## Product Change Notification

1. ECN #: 265473

- TFM - .050 X .050 MICRO STRIPS
- TFML - .050 SHROUDED TERMINAL

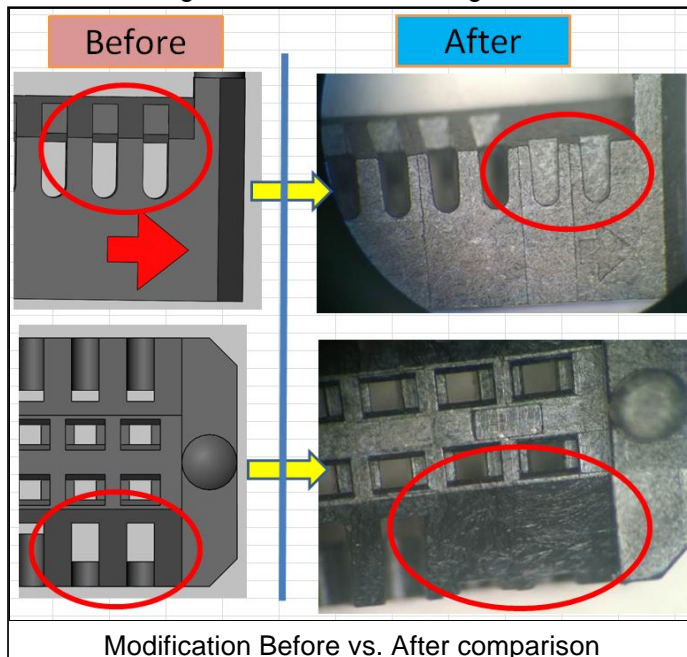
The voids at the keying notch location are being changed from visible(open) to blind(closed).

The current steel design has a poor shut-off condition that requires additional maintenance to manage the flash in the windows. Removing the void in this area eliminates any need for this additional maintenance and eliminates the risk of flashing in this area.

- Form - The voids in the keying notch location are being removed and would be considered only a visual change.
